NOTICE OF DECISION

Design Review – DR220-0008 - Crestview Crossing PUD Commercial Development Site

Crestview Crossing PUD Commercial Development Site – Design Review – DR220-0008

REQUEST: Construction of 5 commercial buildings totaling 37,682 square feet on approximately 4.2 acres

SP
1.1

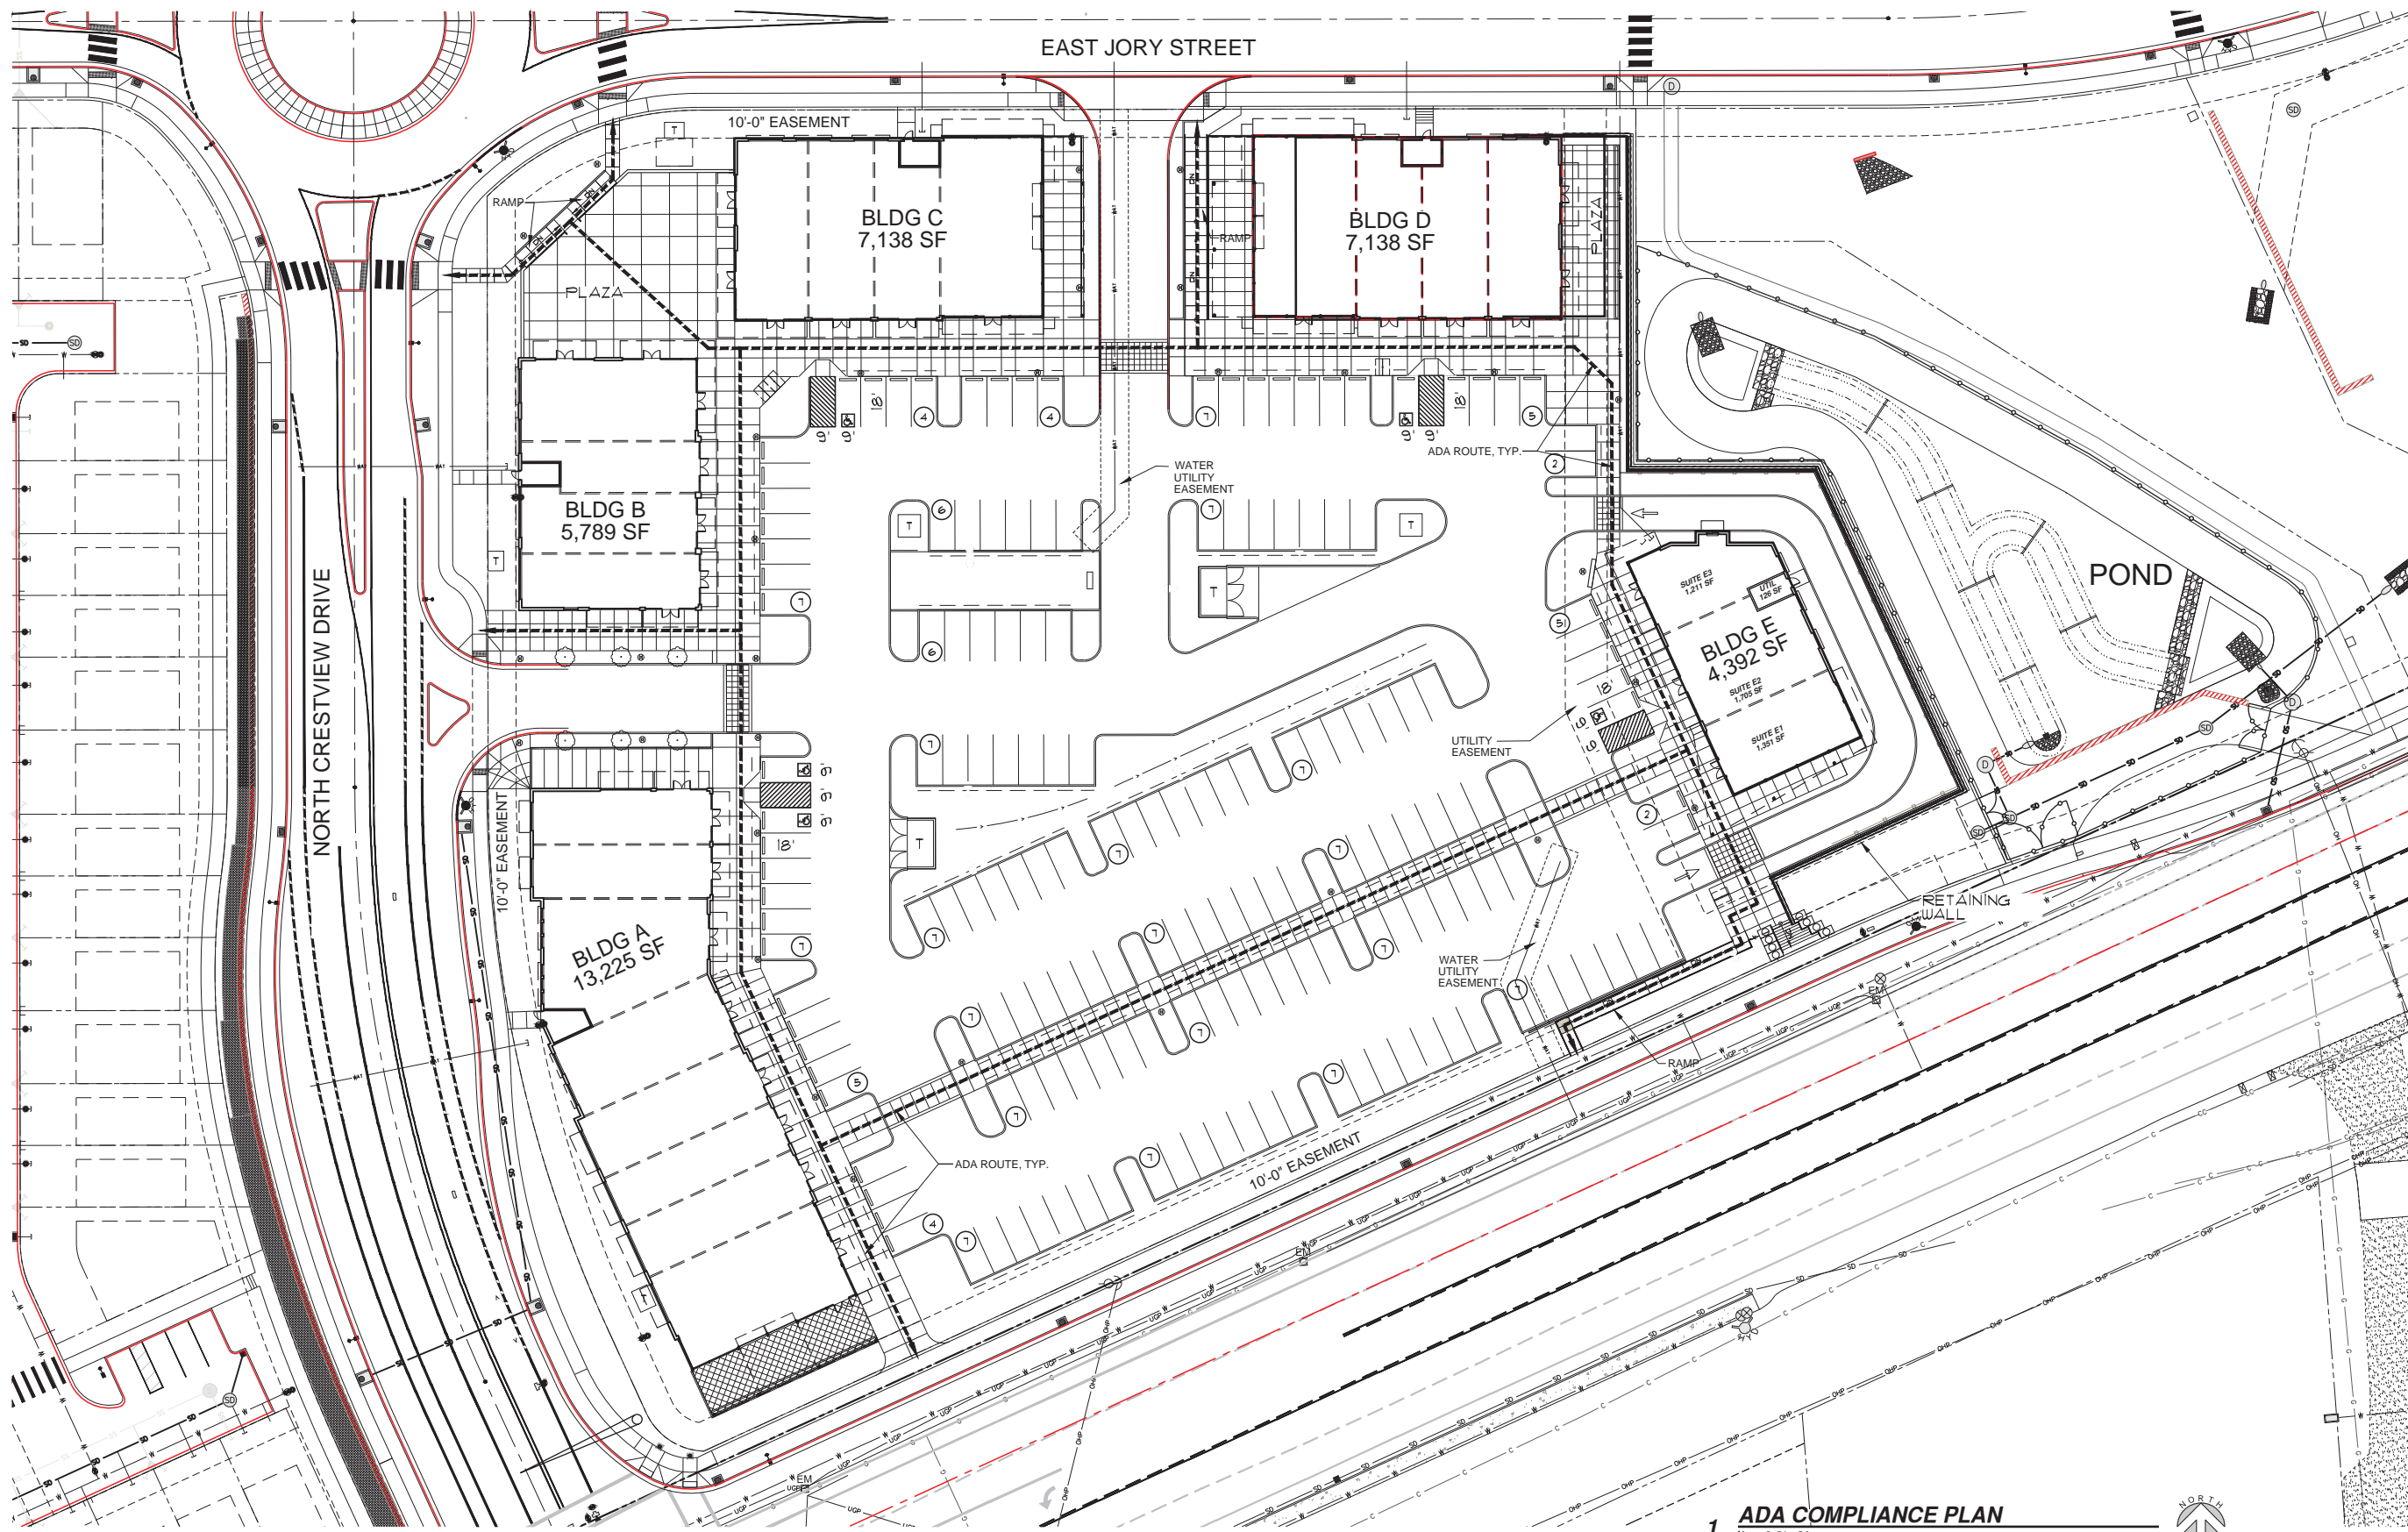
Finding: Sheet 1.1 illustrates two trash and refuse storage areas with each measuring 180 square feet in area and constructed of concrete block with solid gates and protective bollards. Additionally, the developer is proposing small trash receptacles placed throughout the development site for use by customers. Sheet SP 1.1 illustrates the two larger refuse storage areas as centrally located for

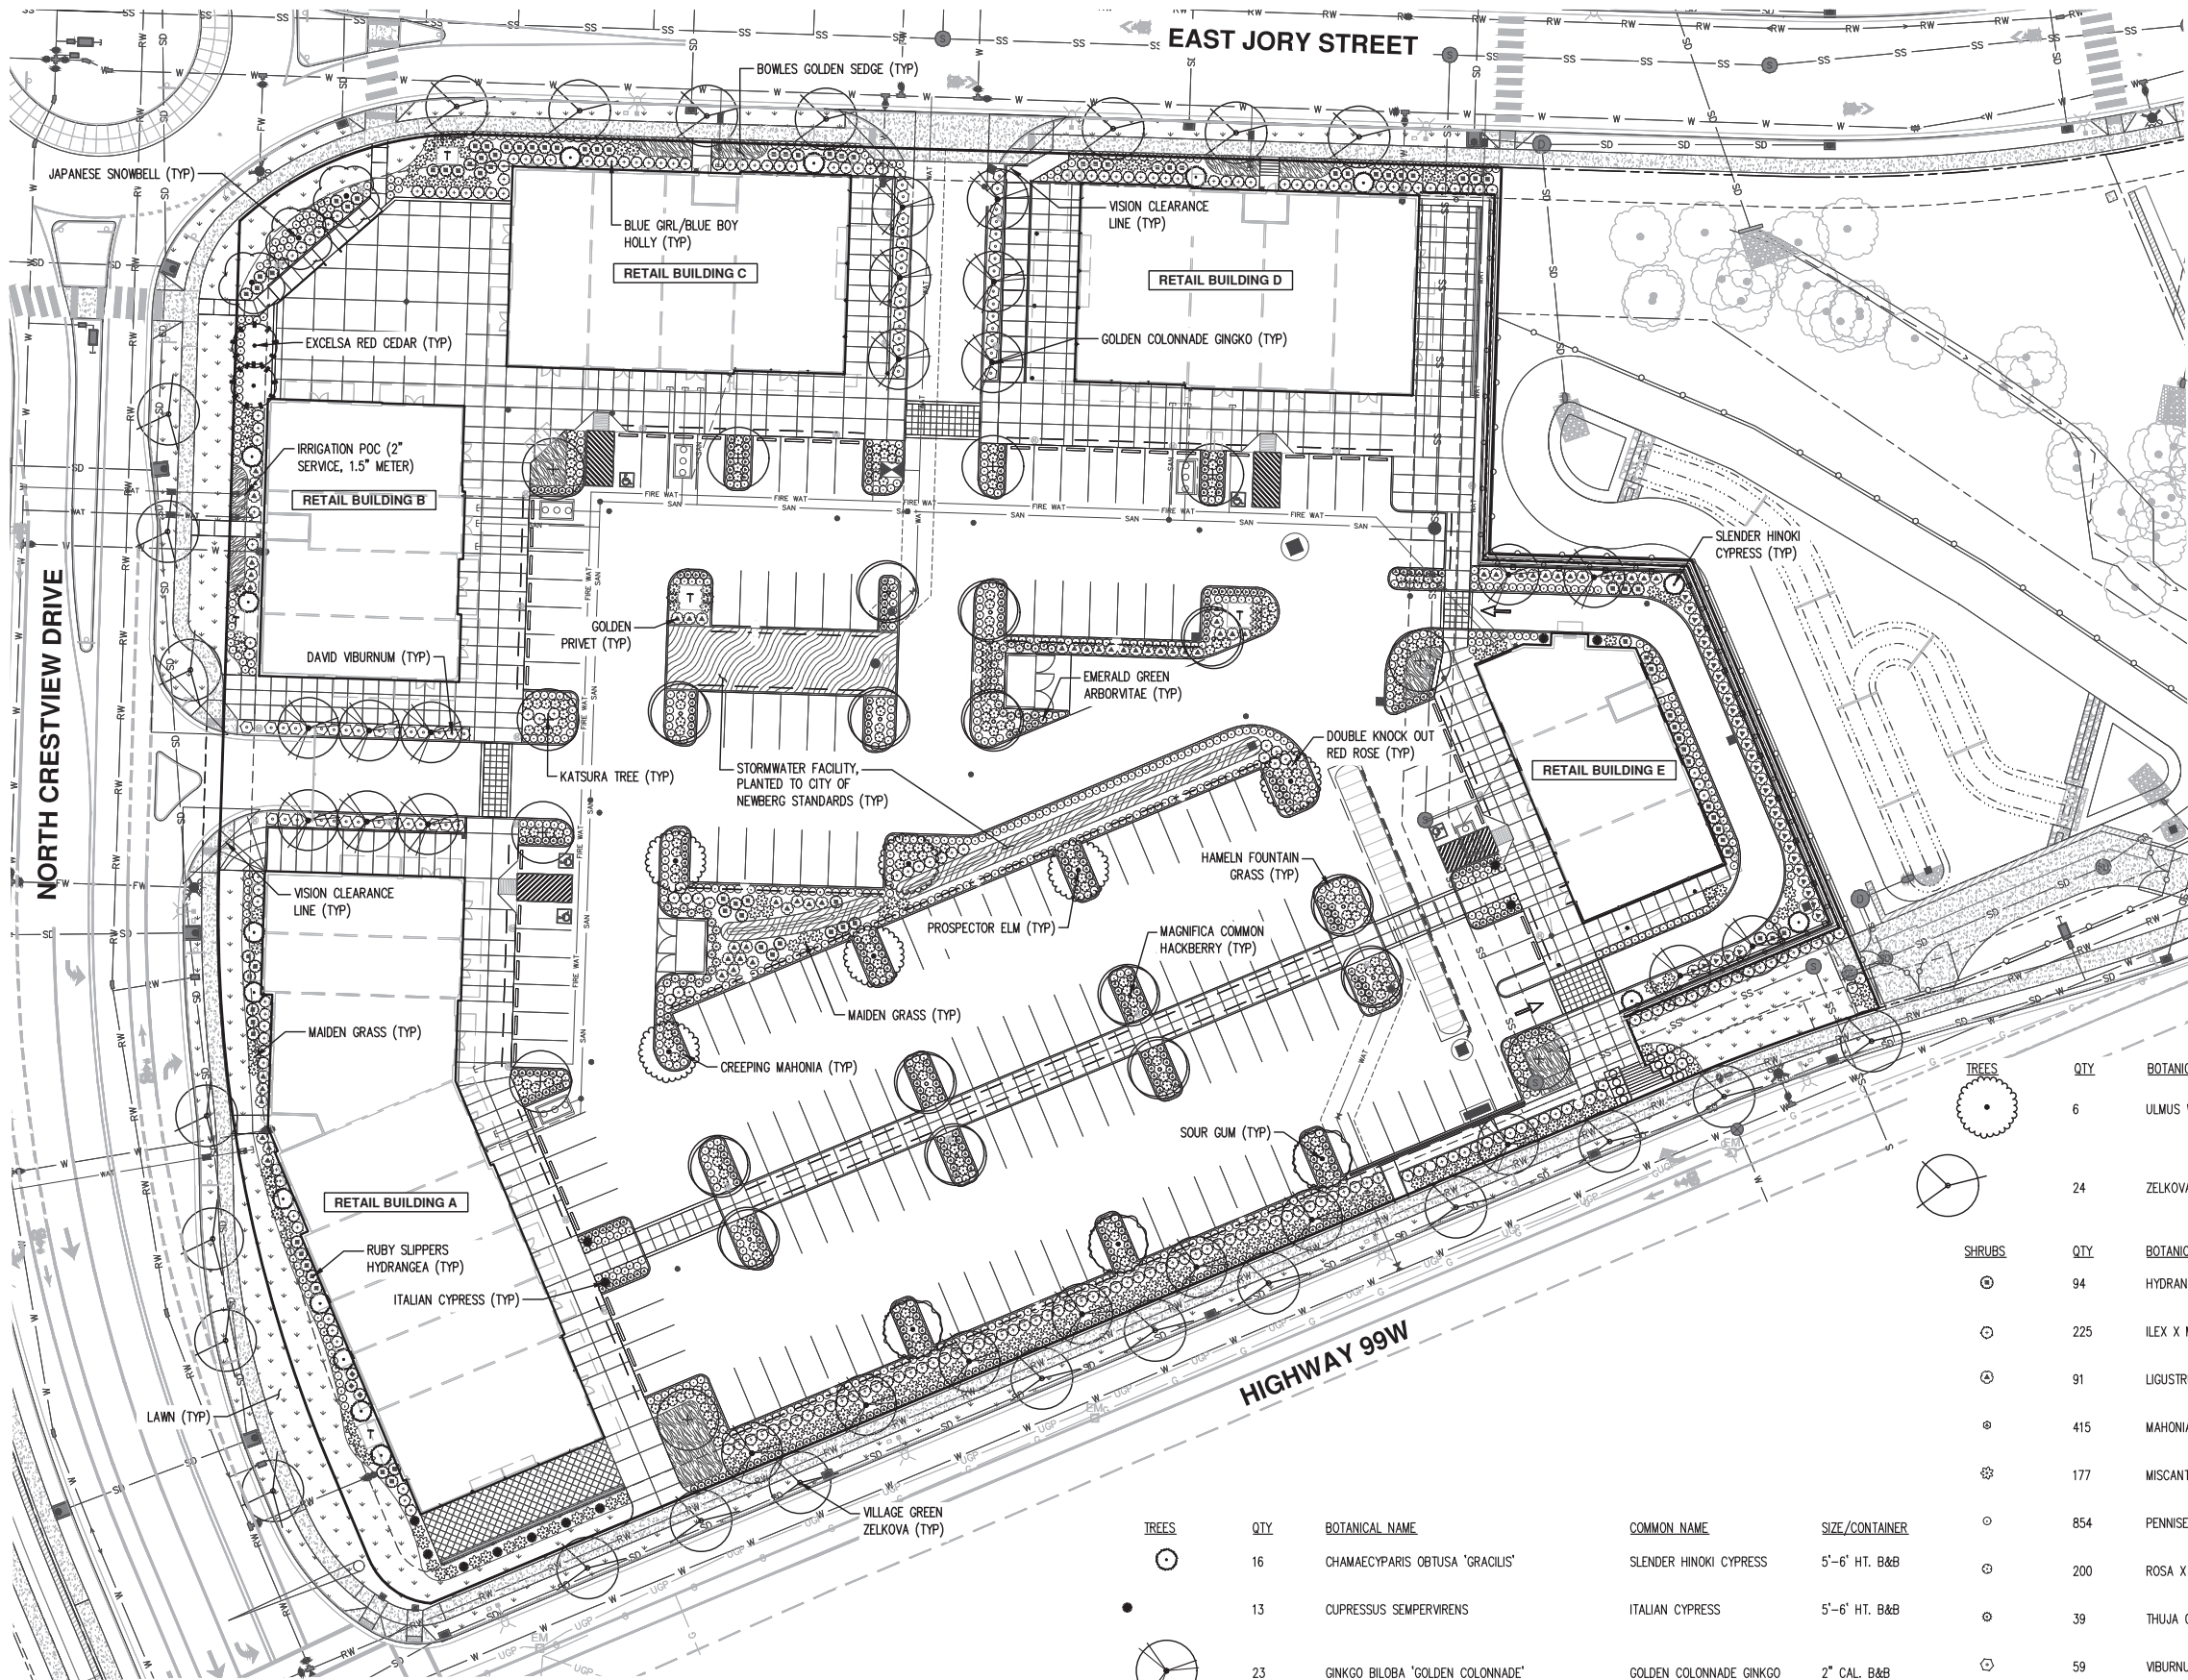
Finding: Sheet L1 illustrates that the parking area will be well landscaped with defined landscaped areas that are uniformly distributed throughout the parking lot. The applicant is not proposing loading areas. This criterion is met.

Finding: Sheet L1 illustrates that all landscaping areas within the parking lot have widths of at least 5 feet. This criterion is met.

Finding: Sheet L1 illustrates that landscaped islands will be constructed in order to break up contiguous blocks of parking spaces. No more than seven parking spaces will be grouped together without a landscape island providing separation from abutting groups of parking spaces. The landscaped islands will have at least one tree planted to provide a partial tree canopy when the trees are full grown. The applicant is not proposing alternative parking lot landscaping standards nor are any needed. This criterion is met.

1 SITE LIGHTING - PHOTOMETRIC PLAN
 E1.0 SCALE: 1/32"=1'-0"

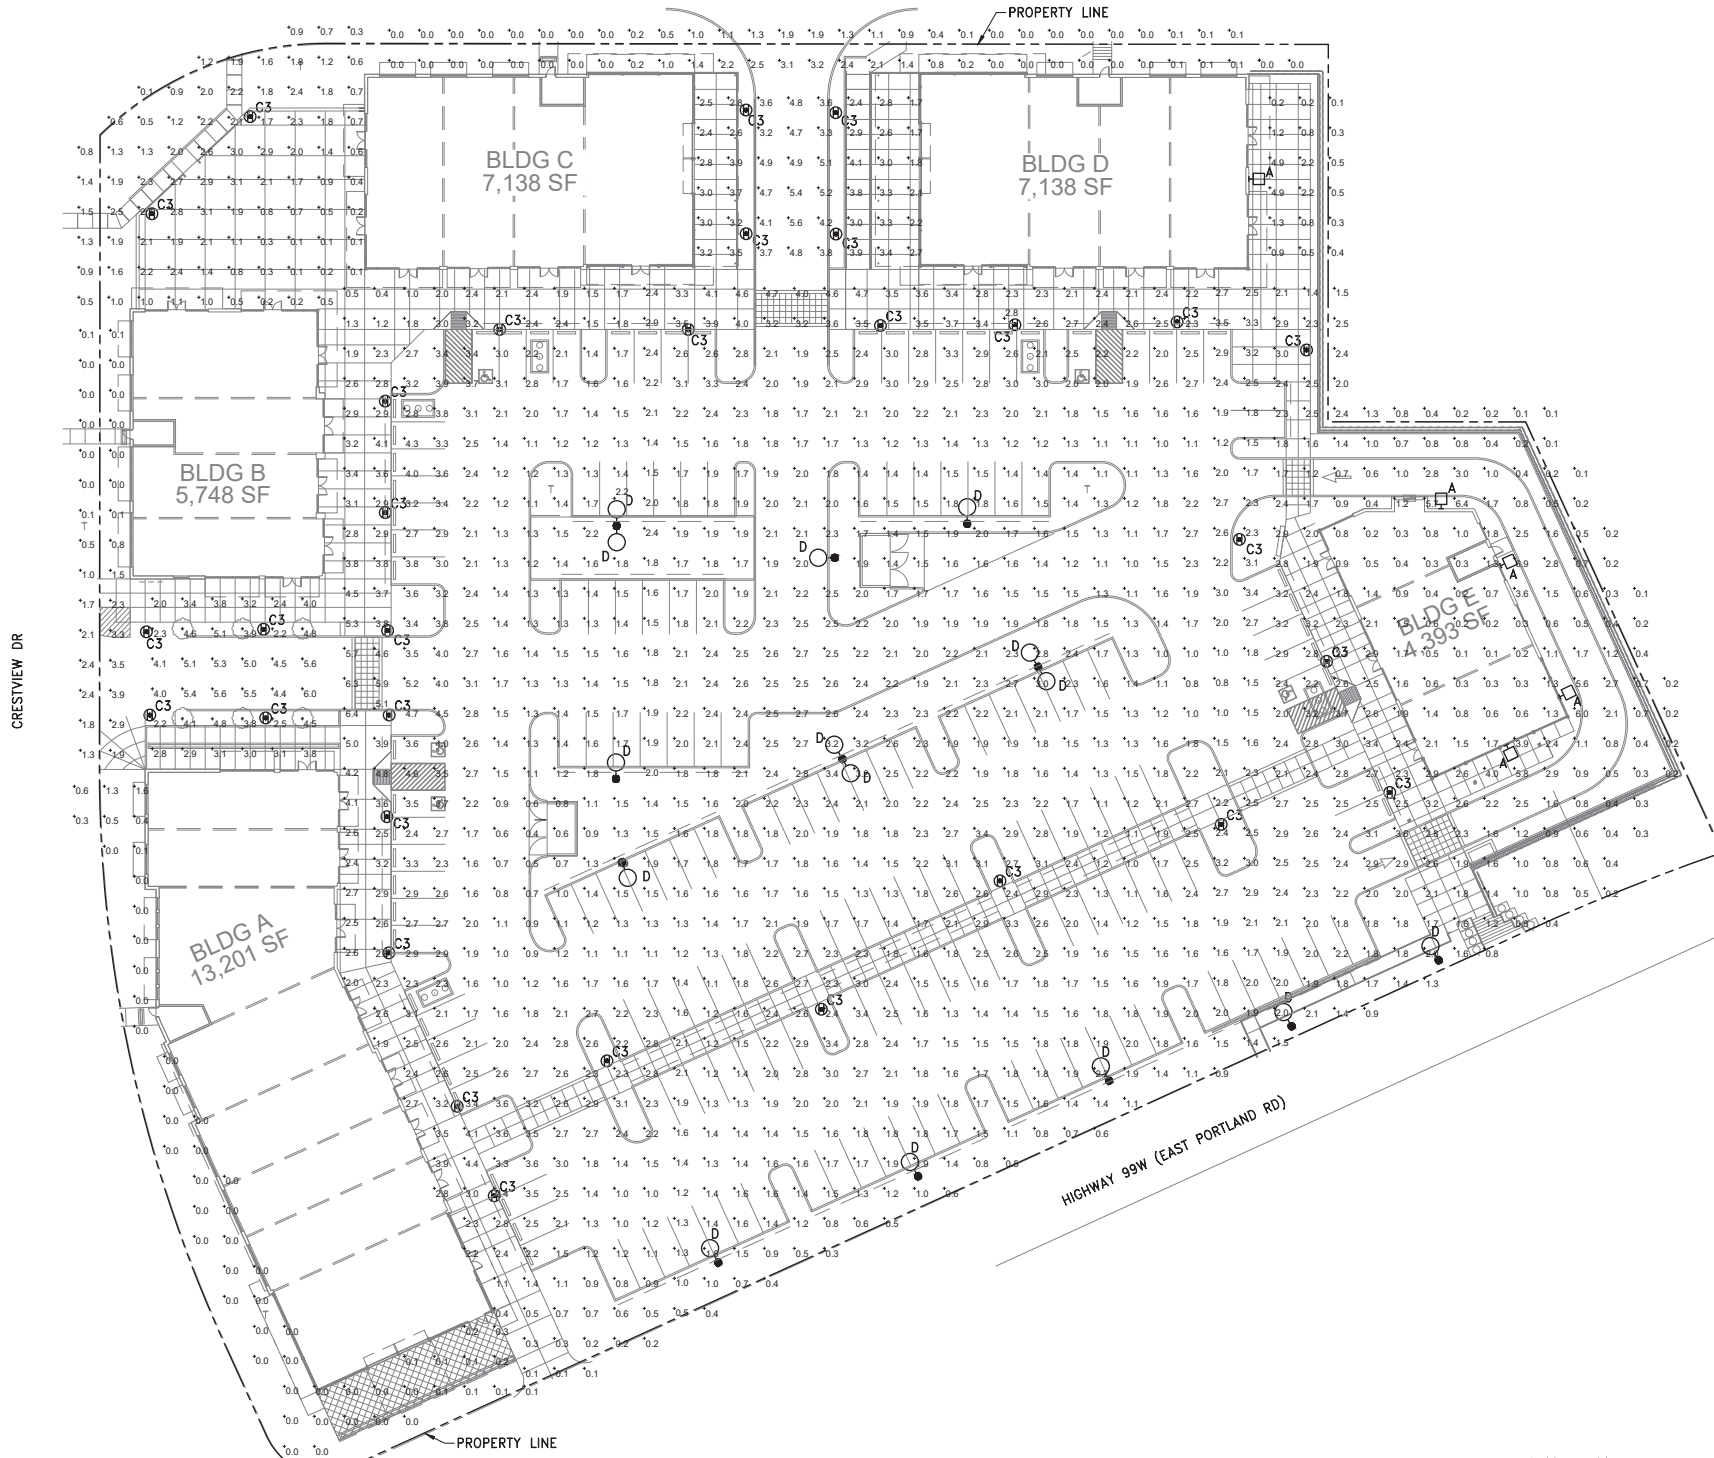
Finding: The applicant has provided a lighting diagram (Sheet E 1.0), which mostly meets the requirements of NMC 15.425.020(1), (2) and (3). It is anticipated that the development site will be utilized after dark. The lighting plan illustrates that the development site will provide enough lighting to provide customers with needed lighting at night for customer safety and personal security. With the building permit application, the applicant will provide additional details regarding wattages and light spectrum to demonstrate compliance with NMC 15.425 because it was not clear from the applicant's lighting information what wattages and light spectrums will be used. This criterion will be met with the adherence to the aforementioned condition of approval.

Finding: Sheet E 1.0 illustrates that the applicant is not proposing low-level light fixtures. This criterion is not applicable.

Finding: Sheet E 1.0 of the applicant's plan set illustrates that 39 medium-level light fixtures and 15 high-level light fixtures will be located throughout the development site. The applicant has provided a photometric diagram illustrating that most of the area around the perimeter of the commercial development site does not have light trespass in excess of 0.5 foot-candle. There are some areas along Highway 99 W, E Crestview Drive, E Jory Street and Tract E (part of the Crestview Crossing PUD) that exceed 0.5 foot-candle at the property line. However, there are no residential lots that abut the commercial development site so light trespass is not an issue. This criterion is substantially met.
